MEETING #2 NOTES

Eastern Corridor Segments II and III

US 50 Corridor Focus Area

Figure I-14C

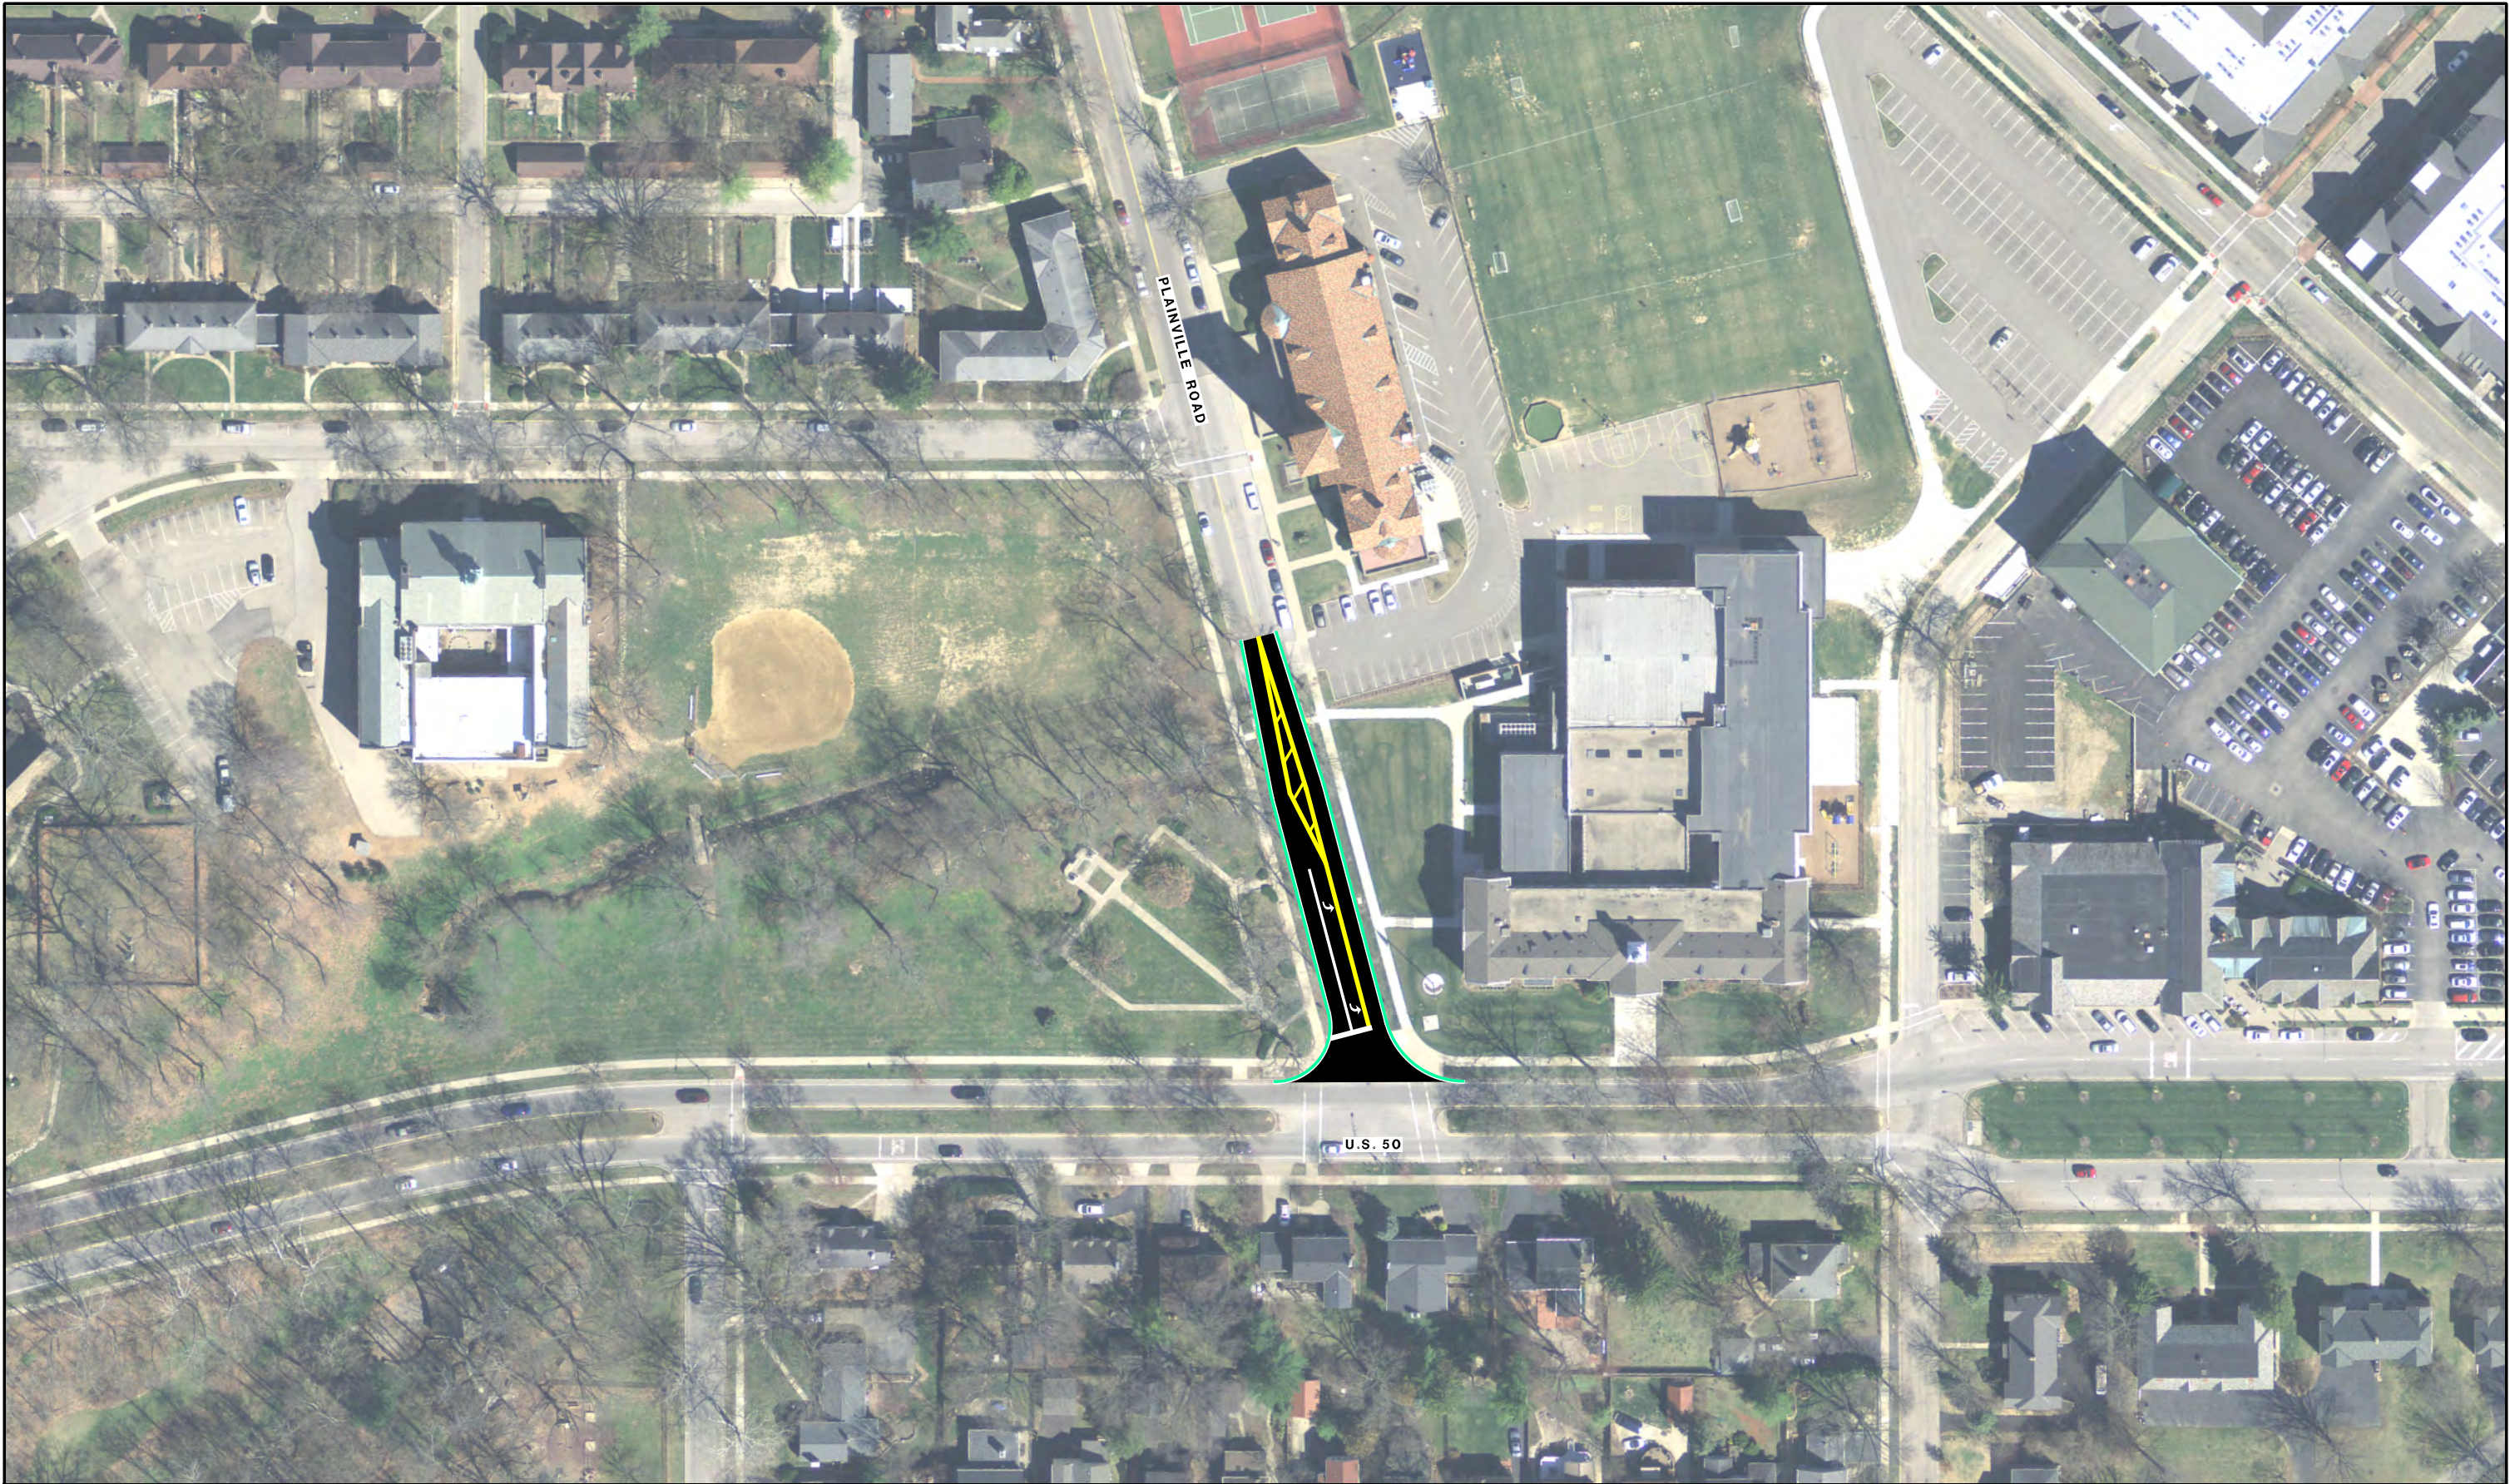
- The current width of lanes on Plainville Road would allow for adding a left turn lane by restriping the existing roadway.
- While this could alleviate the queues of drivers turning left from Plainville Road onto US 50 from blocking drivers turning right, initial analysis showed no traffic benefit of making this change. The southbound approach would still have a failing level of service at the intersection were this change to be implemented.

- (Comments are presented as submitted by Committee members; no edits to content were made.)*
- Mariemont agrees to not further study changes at the intersection.

- Because this concept would not improve the intersection’s overall level of service, no further study is recommended.

Figure 50-4
RESTRIPIING WB BETWEEN WEST STREET
AND MARIEMONT SQUARE
DELINEATE AND EXTEND DROP LANE

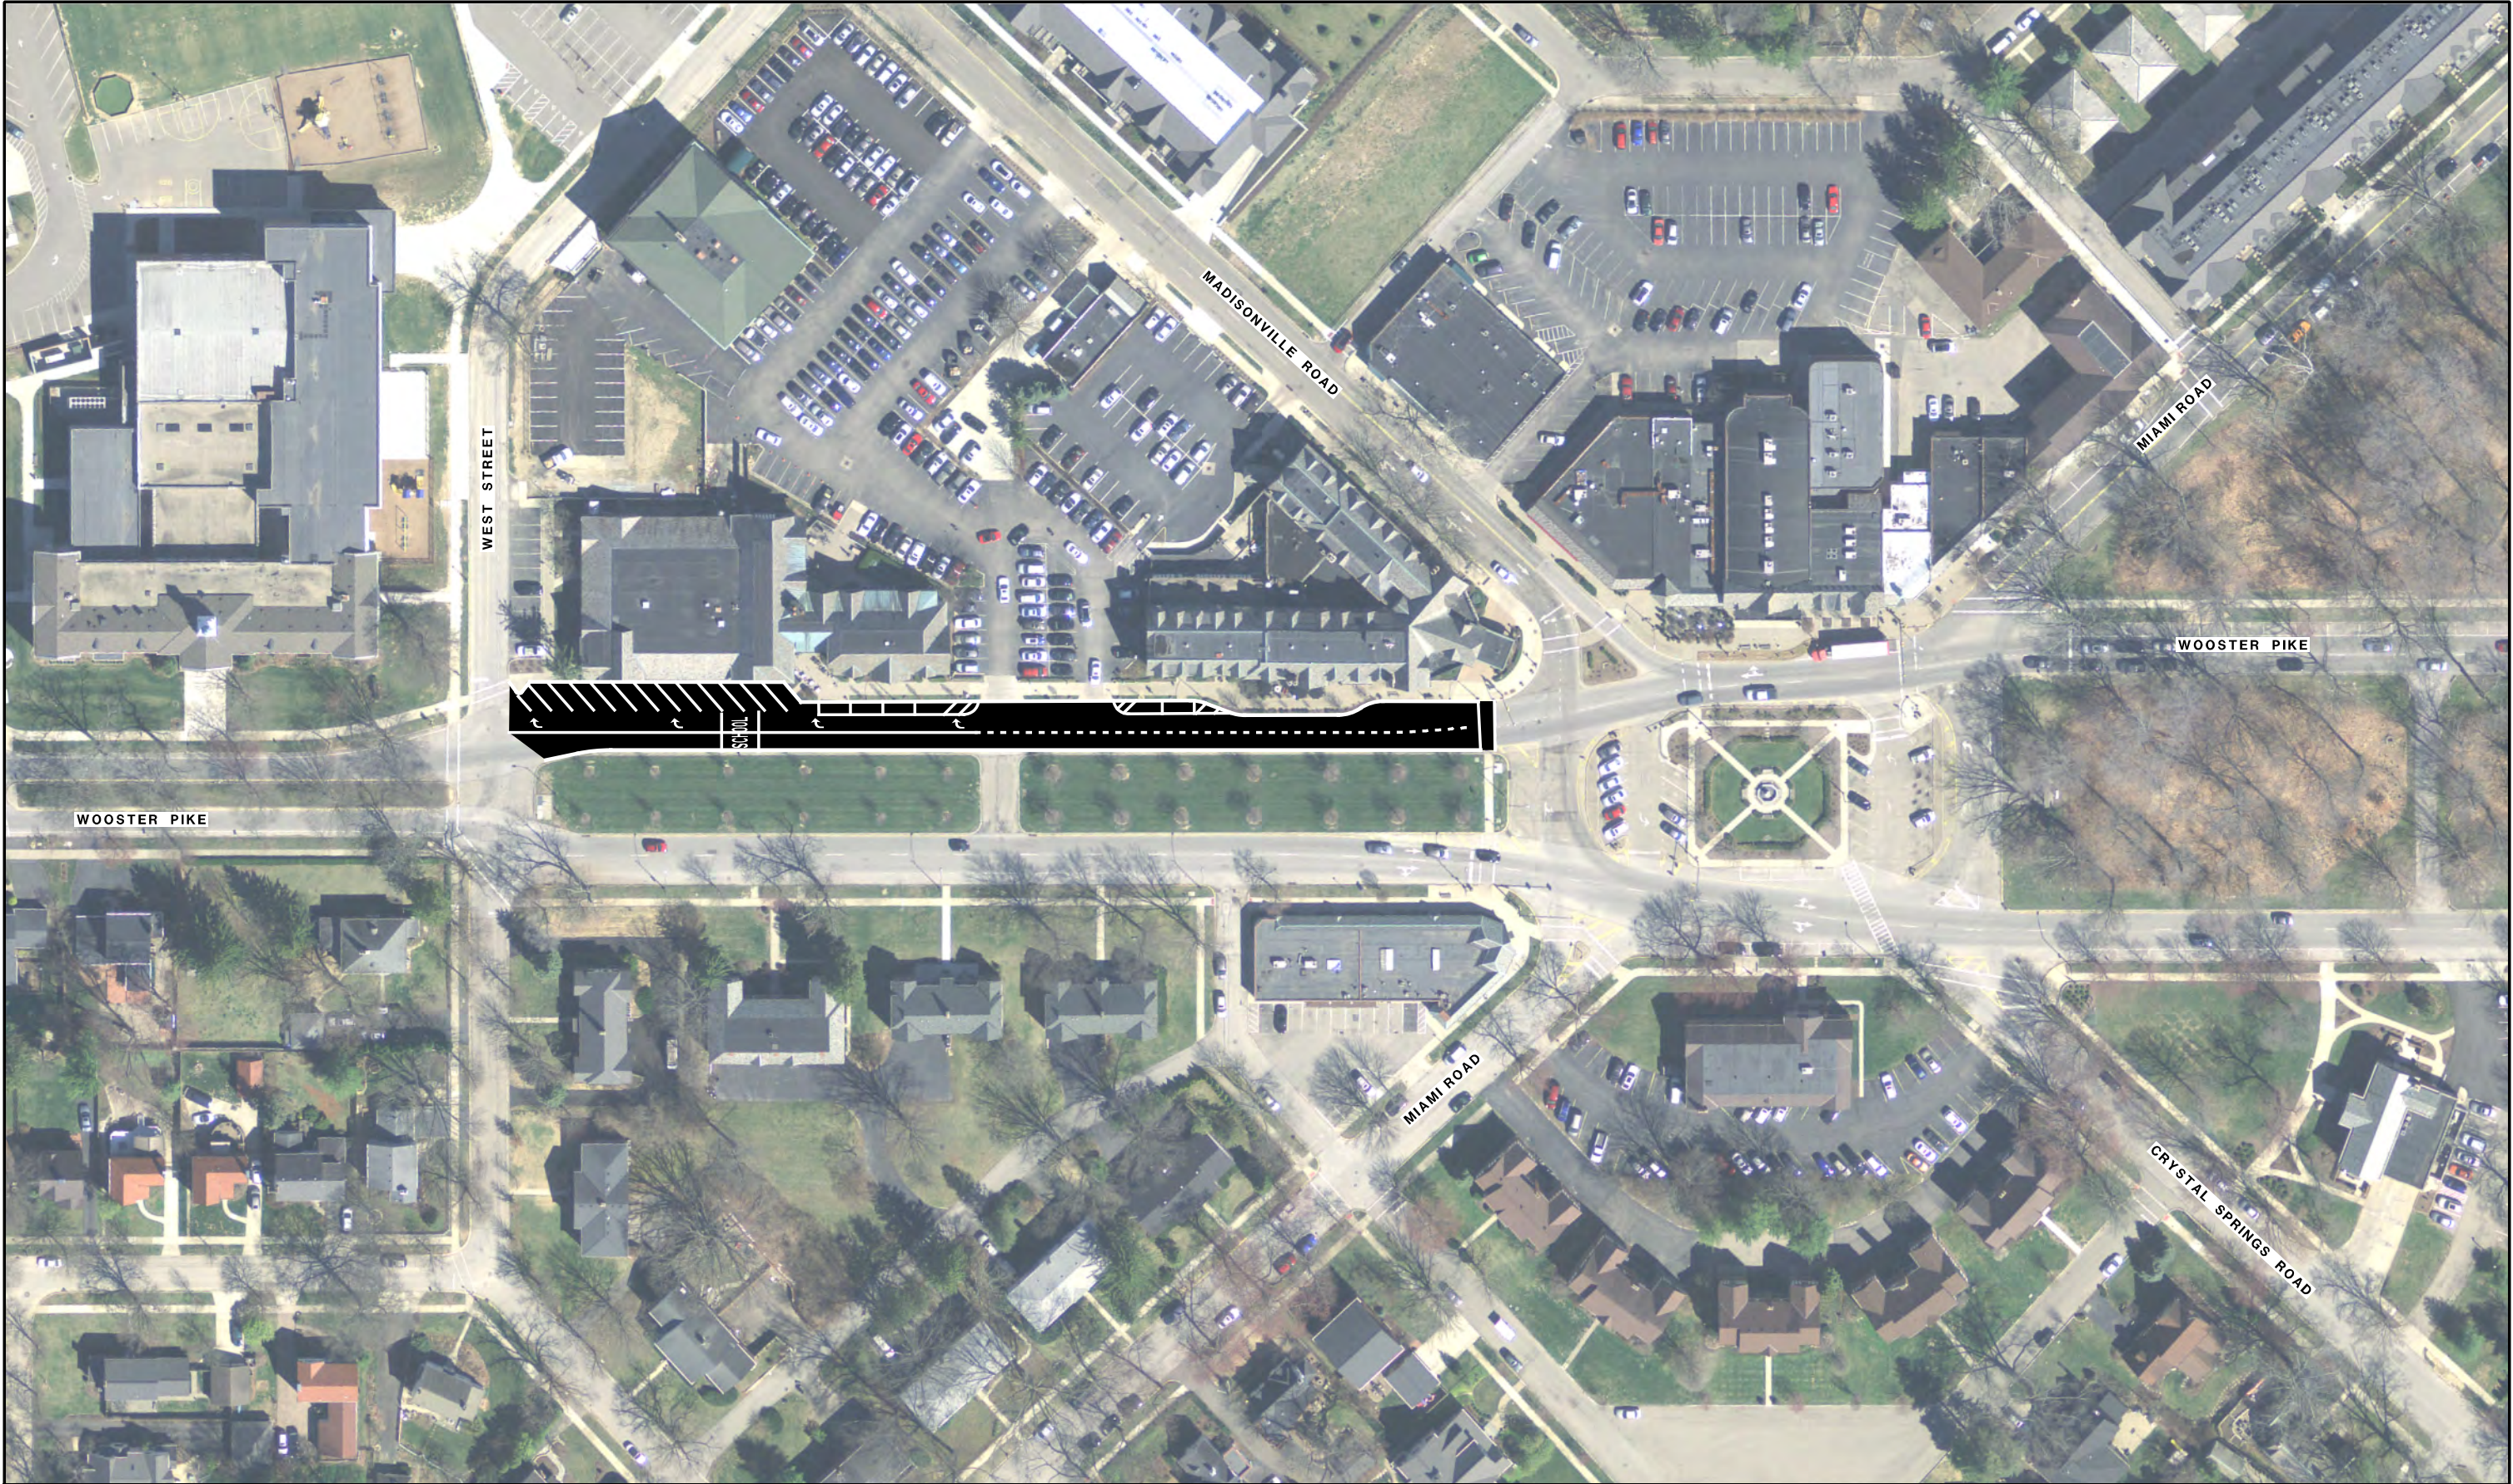
- Currently, there are two westbound traffic lanes through Mariemont Square. However, through traffic in the right lane must merge left past the Square as the right lane becomes a right-turn only lane. This has resulted in a number of side-swipe crashes. (ODOT will pull crash data for review.)

- This concept would restripe the westbound pavement between West Street and Mariemont Square to give drivers more time to merge into the left lane. The dedicated right-turn lane at West Street would remain.

- ODOT is currently planning to resurface this area in 2019 (PID 101309). This concept could be implemented at very little cost as part of that project.

- Impacts to drivers backing out from existing parking for businesses located along this route would need to be evaluated.
- The current pavement markings are intended to encourage drivers to merge left sooner, creating space for cars that are backing out onto the road.

- Mariemont does not approve of extending the drop lane, and discussions with business owners in the area support this. The existing pavement with angled striping is frequently used for deliveries to the businesses, opening up valuable parking for customers within the parking lot.

- Due to a lack of support from Mariemont, this concept will not be advanced.

Alternate drawing for Concept I-13c, submitted by the Village of Mariemont. Drawing is meant to be a starting point for further discussions regarding improved safety at the square.

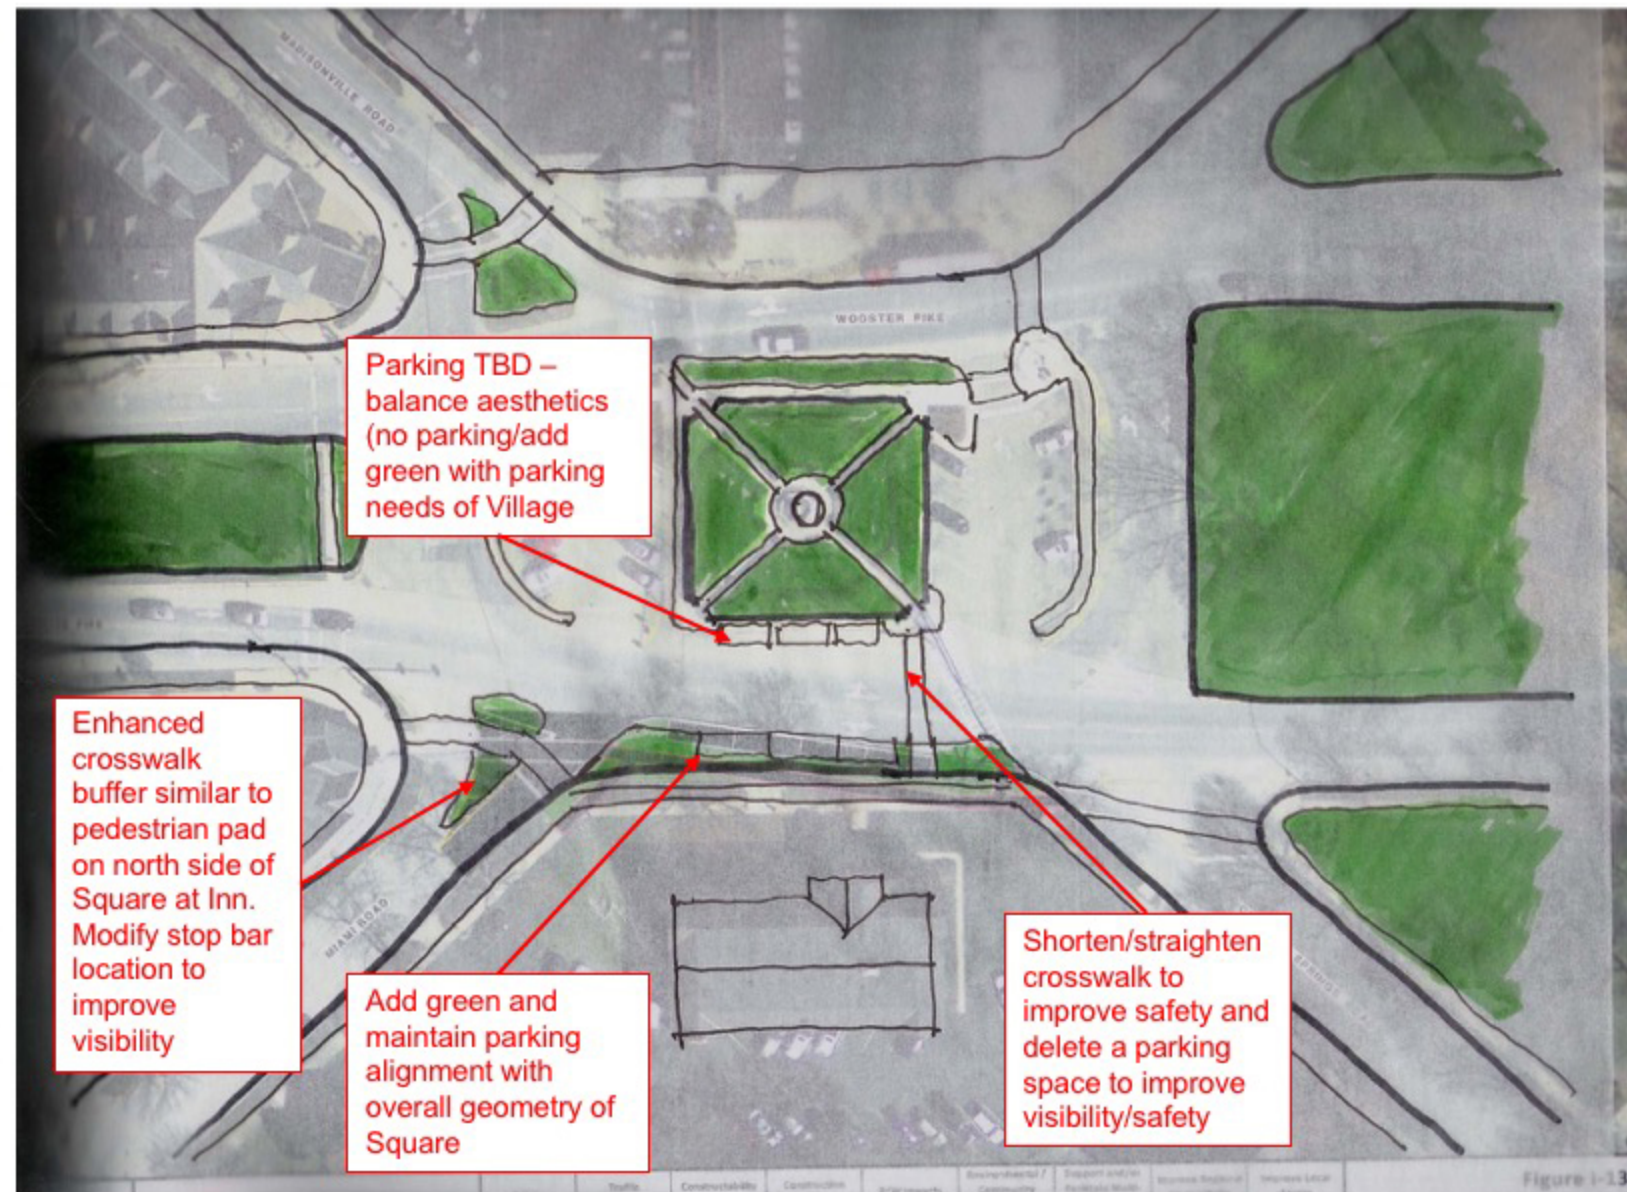
- This concept is intended to address a sight deficiency for drivers traveling northbound on Miami Road and turning right on to Wooster/US 50 (the south side of Mariemont Square). This movement is currently not signalized.
- The addition of a merging lane would be created by adjusting current pavement markings. No existing parking would need to be removed.
- By striping an island, northbound traffic would be able to pull out farther into the intersection to merge more safely.
- Stop signs would be removed and replaced with yield signs
- These changes could be implemented as part of the planned ODOT pavement refresh project (PID 101309) to be completed in 2019.
- Concepts I-3d and I-3e might be better options.

- Mariemont will provide sketch outlining design options. Limited time being allowed to submit comments did not allow Mariemont to submit sketch at this time. Continued dialogue is needed to address safety, parking, and aesthetics.

- Advance for further study.
- Work with Mariemont on concept development.
